# Access Compliance Report

## Public Rights-of-Way

### (Curb Ramps)

Intersection ID: 12715	Main Street: DUNBAR_ST	Cross Street: S_MINT_ST	Location: N
ADA ID: D49A59460CE4	Ramp Type: Directional1	Initial Pass/Fail: Fail	Overall Compliance: No
Severity Score: 58.75			
Codes/Mitigation Info/Possible Solution		Field Measurements/Component Compliance

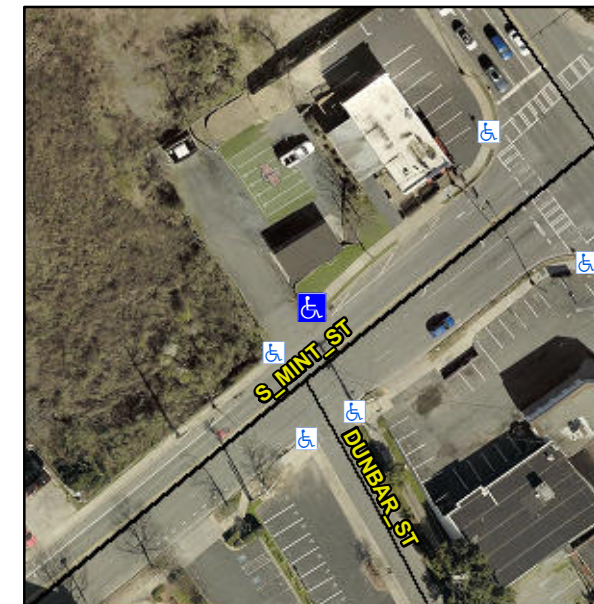
**R304.5.1, R304.2.2, R304.5.3**

Compliance	Description	Data	Compliance	Description	Data
N/A	Ramp Length (in)	77.0	N/A	Grade Break?	N/A
No	Ramp Width (in)	44.5	N/A	Grade Break Slope (%)	0.0
No	Ramp Slope (%)	12.3	N/A	Grade Break XSlope (%)	0.0
No	Ramp XSlope (%)	8.5			
N/A	Flare Type LT	N/A	N/A	Flare Type RT	N/A
N/A	Flare Slope LT (%)	N/A	N/A	Flare Slope RT (%)	0.0
N/A	Flare Traversable LT?	N/A	N/A	Flare Traversable RT?	N/A
N/A	Landing Length (in)	0.0	N/A	DWS Provided?	N/A
N/A	Landing Width (in)	0.0	N/A	DWS Contrast?	N/A
N/A	Landing Slope (%)	0.0	N/A	DWS Length (in)	N/A
N/A	Landing X Slope (%)	0.0	N/A	DWS Full Width?	N/A
N/A	Landing Curb? (Y/N)	N/A	N/A	DWS Offset LT (in)	N/A
N/A	Shared Landing?	N/A	N/A	DWS Offset RT (in)	N/A
N/A	Gutter Ponding?	0.0	N/A	Gutter Slope (%)	N/A
N/A	Gutter Lip Ht (in)	0.0	N/A	Gutter X Slope (%)	N/A
N/A	Painted X Walk1?	No		Road Slope (%)	1.4
	X Walk 1 Direction	To SW		Road X Slope (%)	4.2
	X Walk 1 Width (in)	N/A		Clear Space?	N/A

**Remove & Replace Entire Ramp.**
